S.I. M20-54  
DATE 1-19-81

**SUBJECT:** Installation of Cushioned Retainer Assemblies behind light bulbs.

Mooney Model M20K, S/N 25-0001 thru 25-0609.

**FIGURE 1**

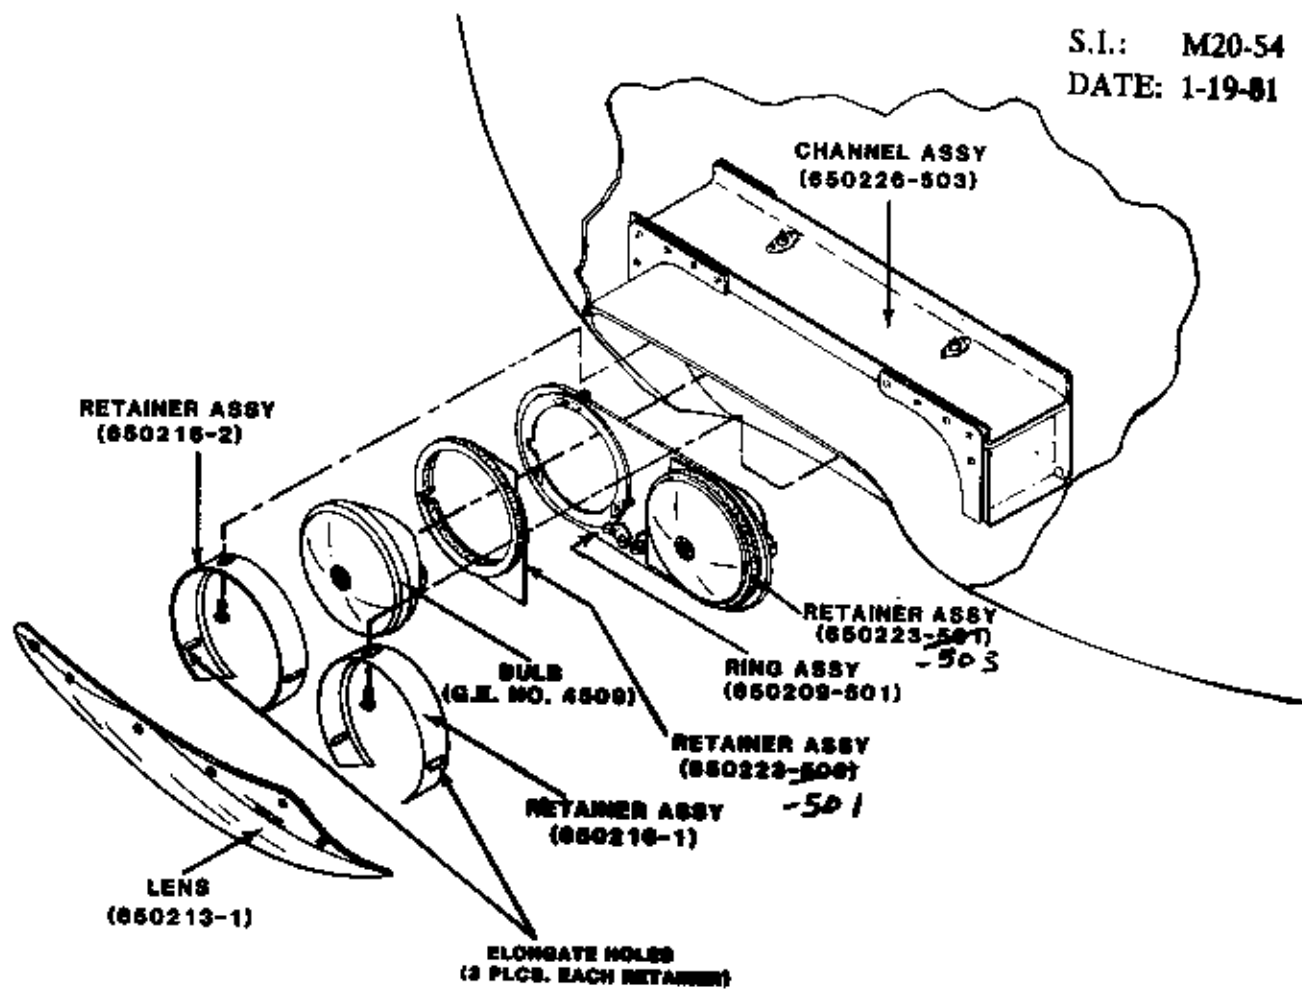
Reports from the field have indicated failure of landing light bulbs. In some cases the bulb is cracked causing the filament to be destroyed when landing light is turned on.

1. Remove the landing light lens P/N 650213-1 from the front of cowling.
2. Remove retainer rings, P/N 650216-1 & -2, from front of light bulbs. Retain for rework and reinstallation later. (Ref. Figure 1)

3. Pull light bulbs out from mounting brackets and disconnect electrical wires.
4. Place new retainer assemblies, P/N 650223-501 and -503, cushion side toward bulb, in place against ring assy, P/N 650209-501. (Ref. Figure 1). Trim edges to fit inside landing detent in cowling if necessary.

5. Rework the (2) retainer rings removed earlier, P/N 650216-1 and -2 by elongating the three holes in each ring, aft direction, to allow ring to be attached when the cushioned retainers push the light bulbs forward from their original position.

6. Reinstall light bulbs and reconnect electrical wiring.
7. Reinstall L.H. & R.H. retainers, P/N 650216-1 and -2, positioning them snugly against the light bulb and securing with original screws. The reason for the slotted holes will be apparent here.

**FIGURE 2**

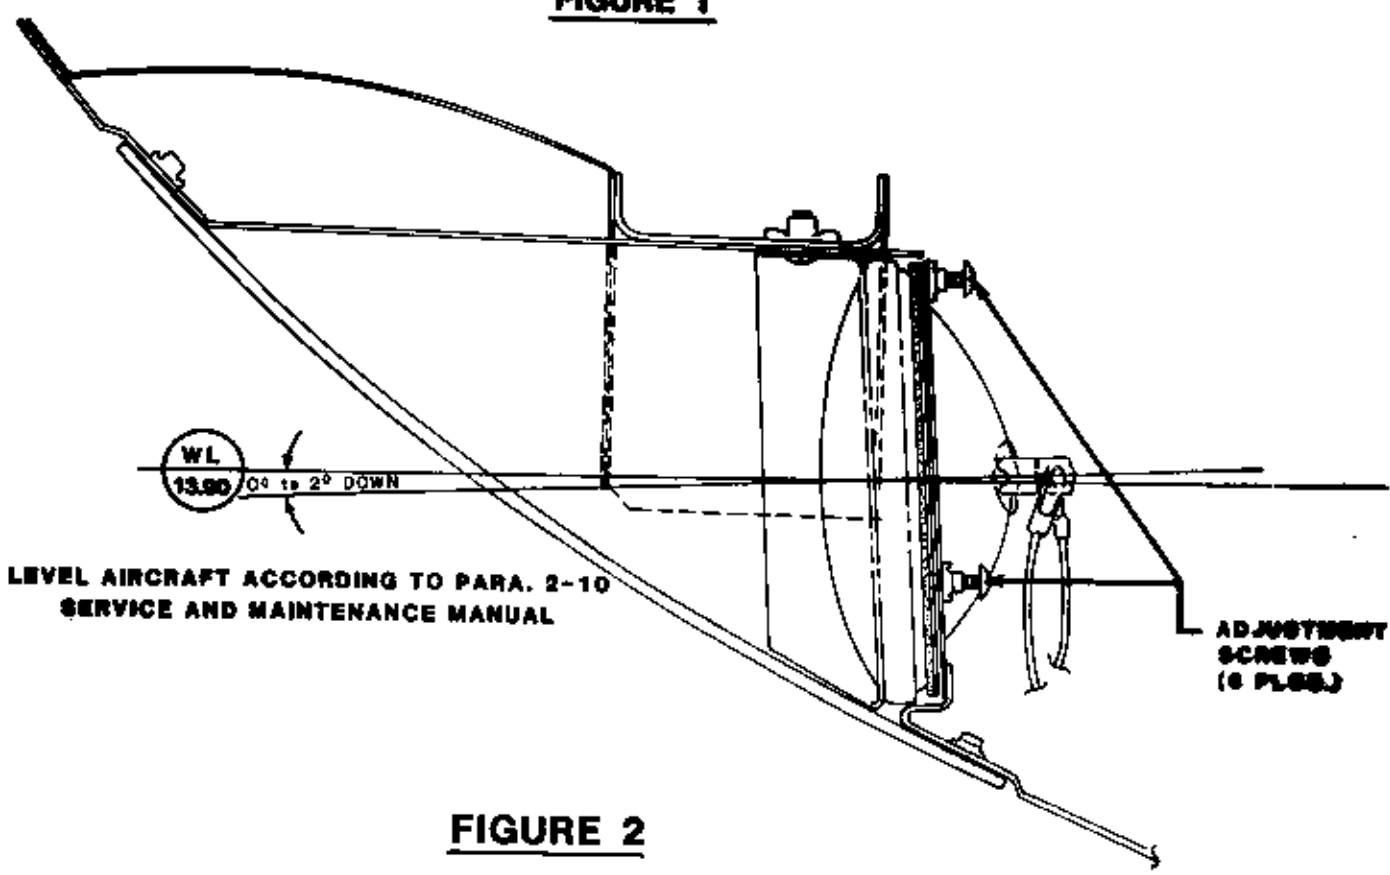
8. Check rigging and operation of the landing lights when installation is completed, ref. Figure 2.
9. Enter compliance note in Aircraft Log Book and return aircraft to service.
